# DESIGN COMMISSION REGULAR HYBRID MEETING AGENDA

1. Design Commission Meeting Minutes for November 2, 2022  
**Recommended Action:** Approve minutes.
2. DSR22-014 – Review a proposal to construct a new 10-unit apartment building at 2900 78<sup>th</sup> Avenue SE.  
**Recommended Action:** Discussion only

<b>Project No:</b>	DSR22-014
<b>Description:</b>	A Study Session with the Design Commission to discuss a proposal to construct a new 10-unit apartment building.
<b>Applicant/ Owner:</b>	Kelly Hallstrom (Medici Architects) / 2900 Development LLC
<b>Site Address:</b>	2900 78th Ave SE, Mercer Island WA 98040
	Identified by King County Assessor tax parcel number: 531510-1219
<b>Zoning District</b>	Town Center (TC), TC-4 Subarea
<b>Staff Contact:</b>	Ryan Harriman, EMPA, AICP – Planning Manager
<b>Exhibits:</b>	<ol style="list-style-type: none"> <li>1. Project Narrative</li> <li>2. Plan Set</li> <li>3. Building Study Session Comments</li> </ol>

GARAGE FLOOR PLAN  
1/4" = 1'-0"

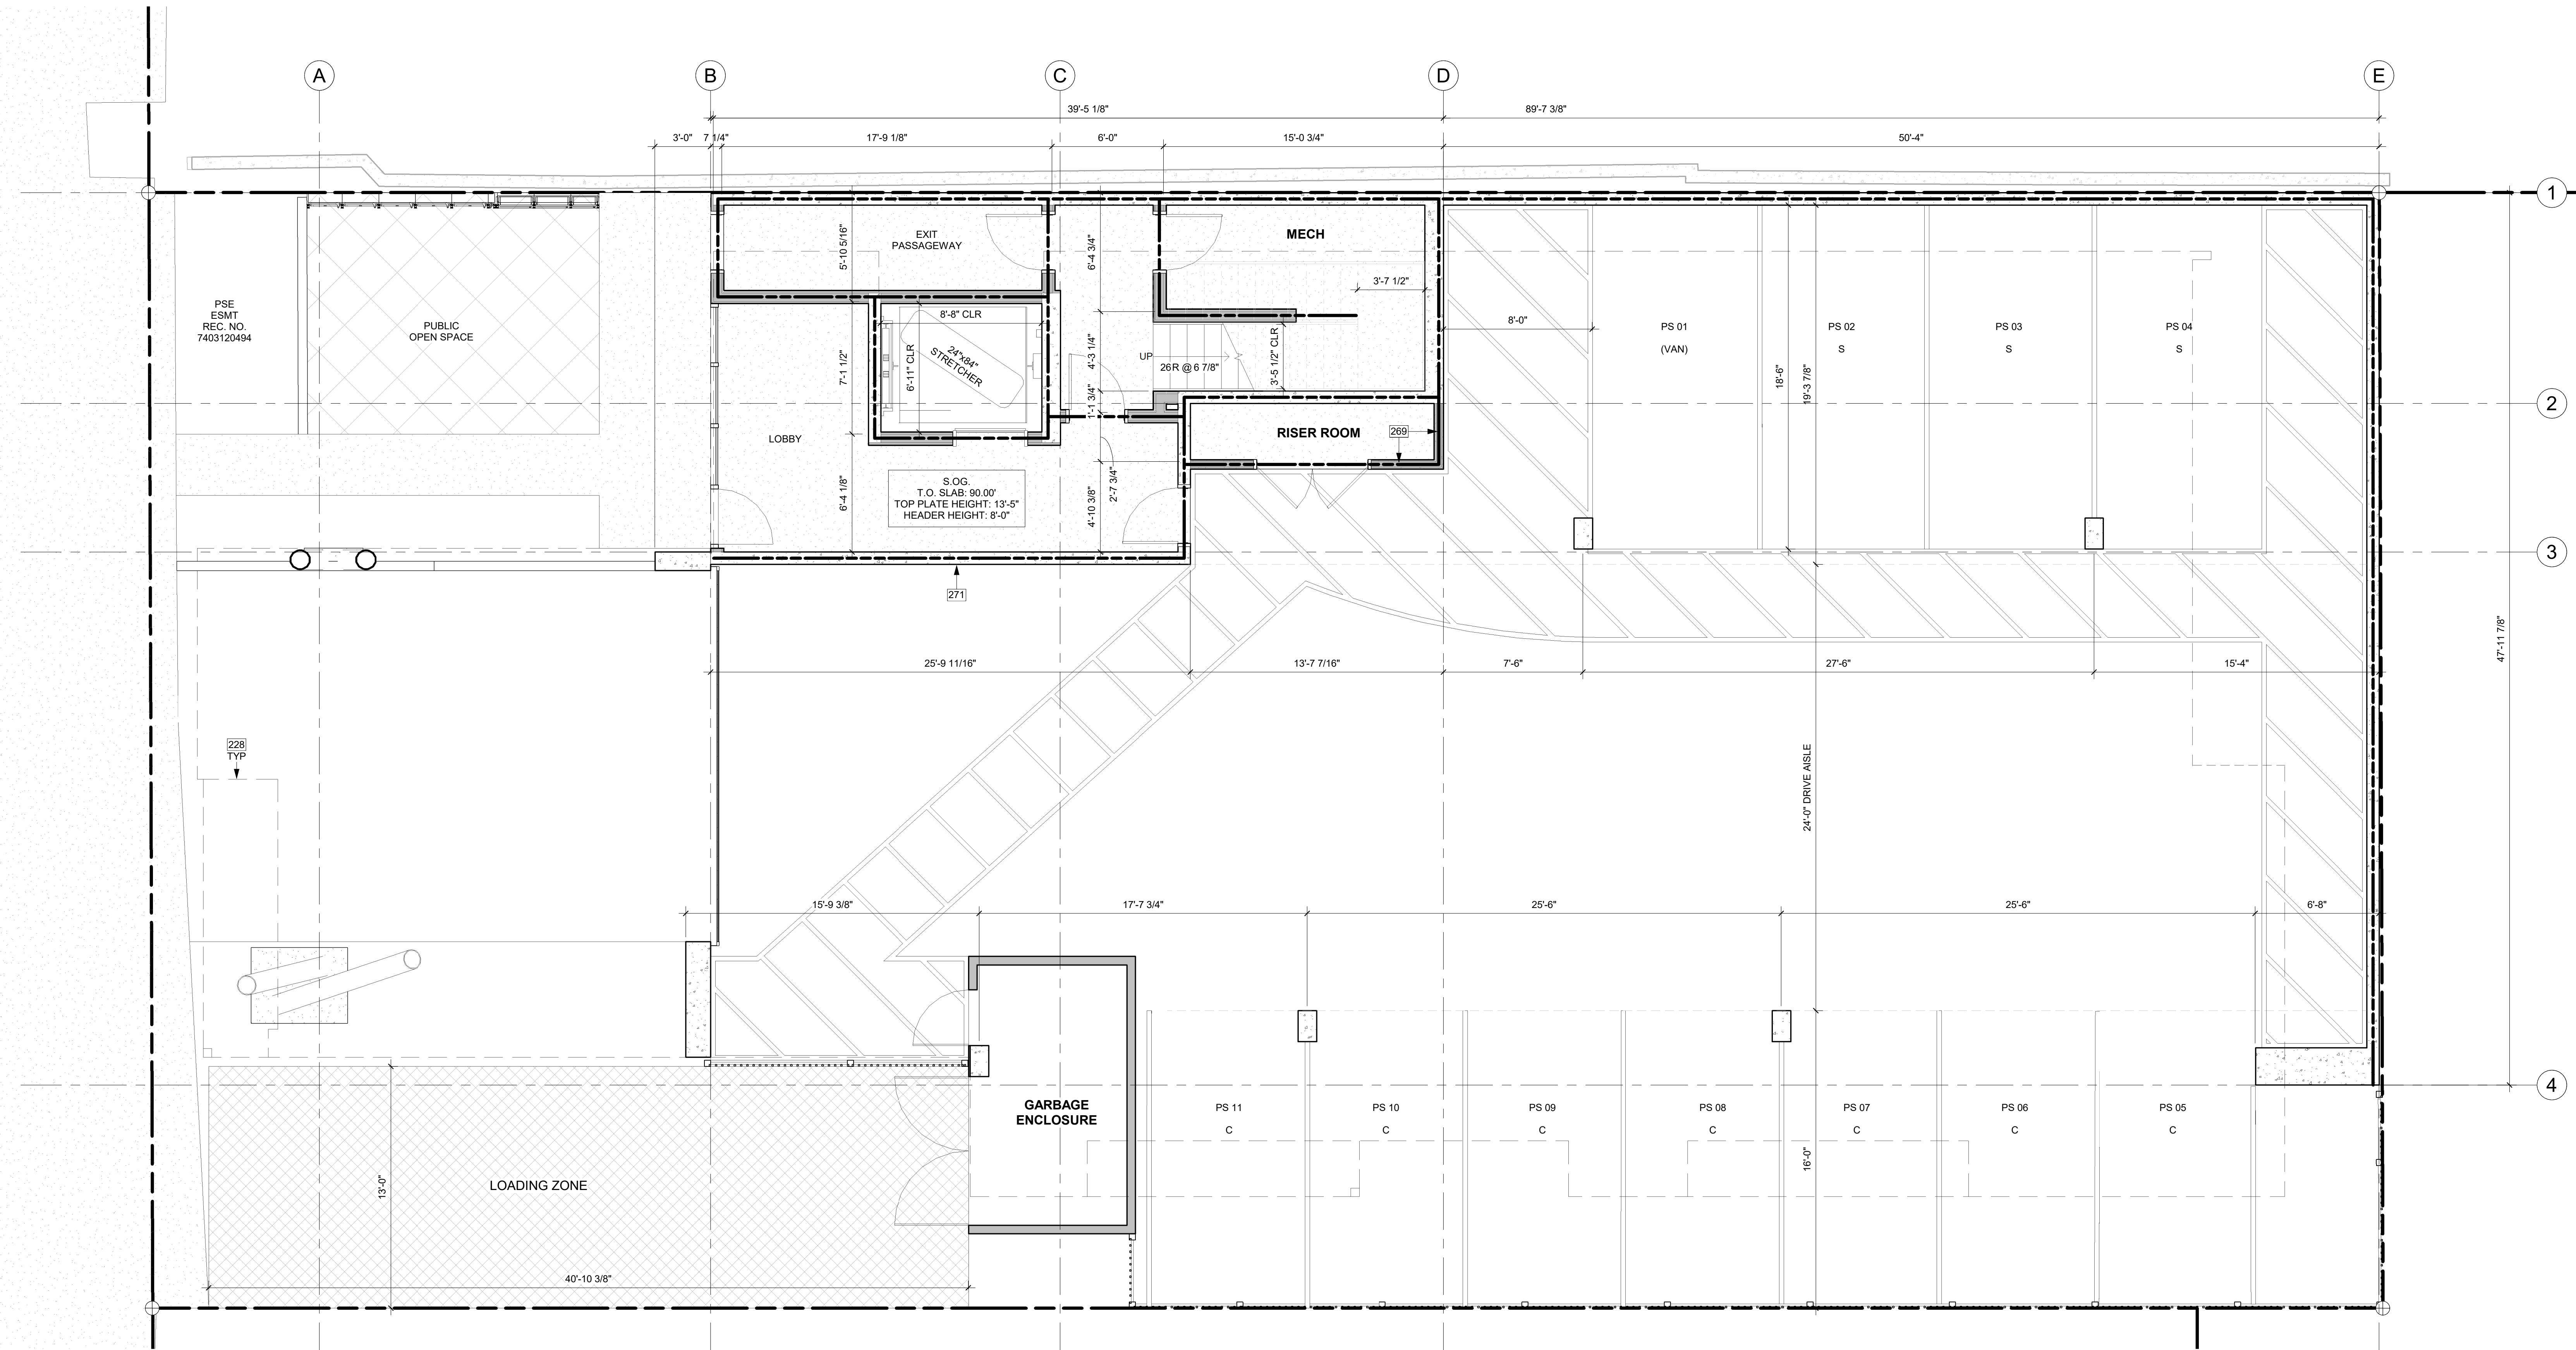
2. The numbering of stories used on sheets A0.1b and all A4.x sheets is not consistent with definition for Story Above Grade Plane. WSBC definition for Story Above Grade Plane is any story in which the next story above is more than 6' above grade plane. Re-numbering the stories to conform to this definition, the garage floor plan is the 1<sup>st</sup> story

ROOF PLAN  
1/4" = 1'-0" 1

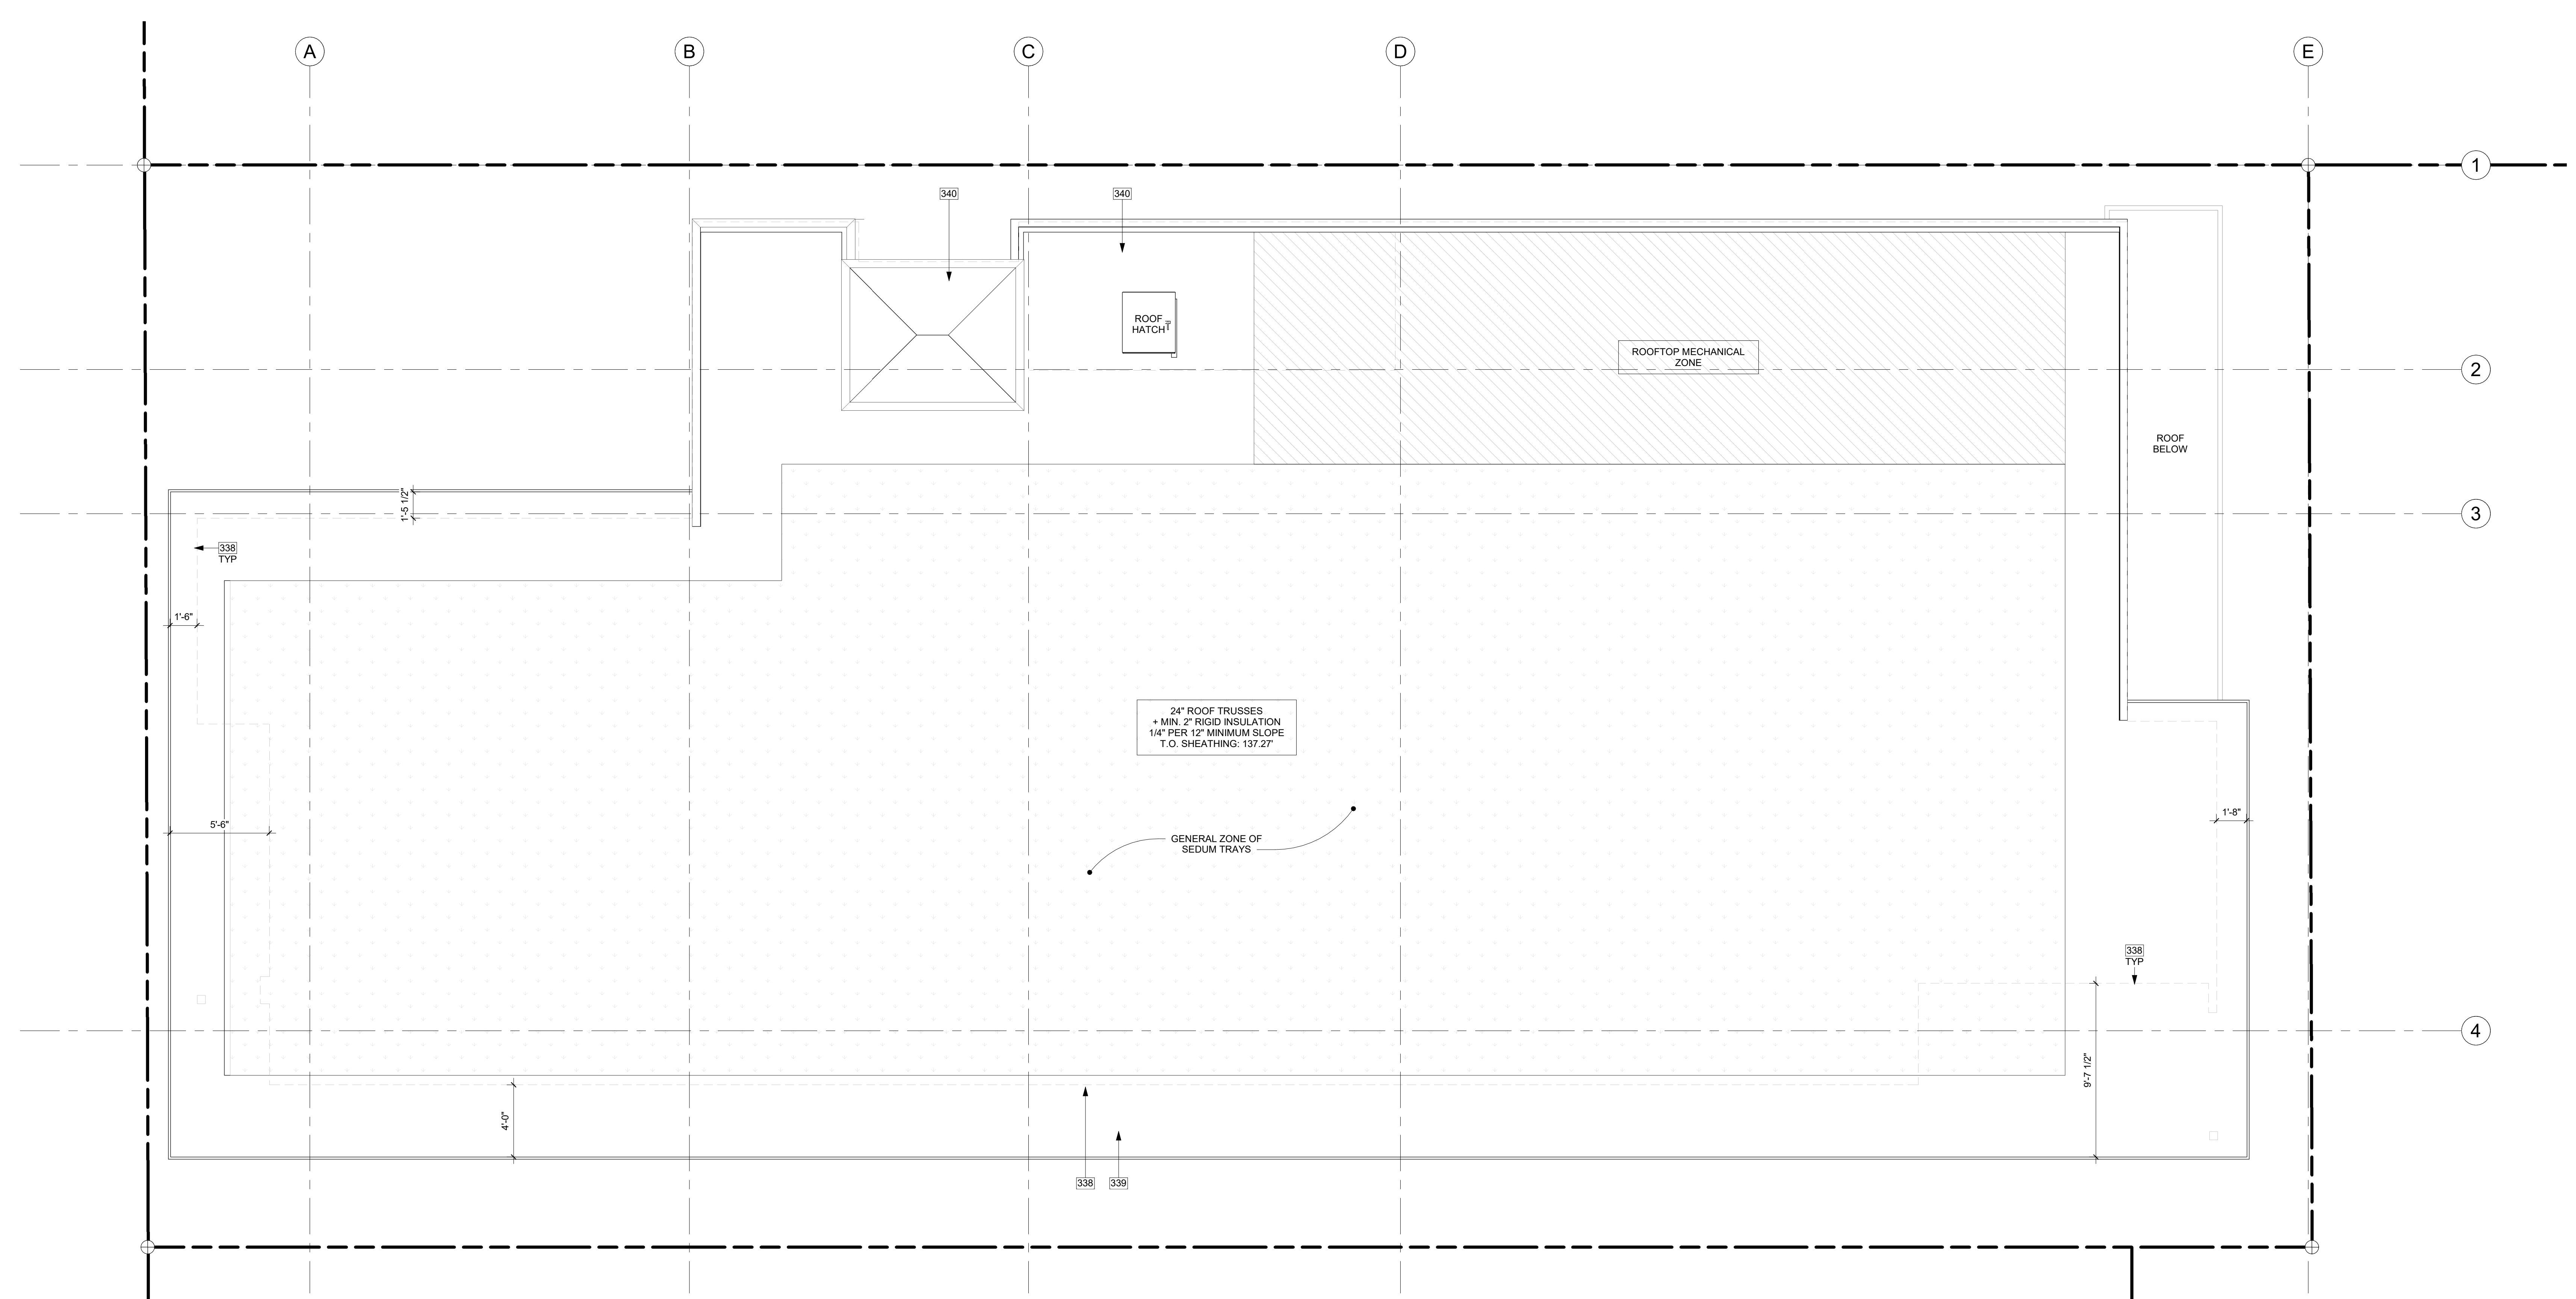
6. Previous discussion of this proposal as part of PRE21-032 and PRE22-027 referred to occupiable roof deck. The documents submitted along with DSR22-014 do not appear to include this use, but the roofing systems and thus exterior elevations are not clear. The roof elevation on A4.x sheets is noted as top of roof sheathing and does not include consideration for slope for drainage. A 1/4" per foot slope will create at least a 1' difference in height between north and south elevations, and the roof planting plan L1.0 appears to show a hip framed roof.
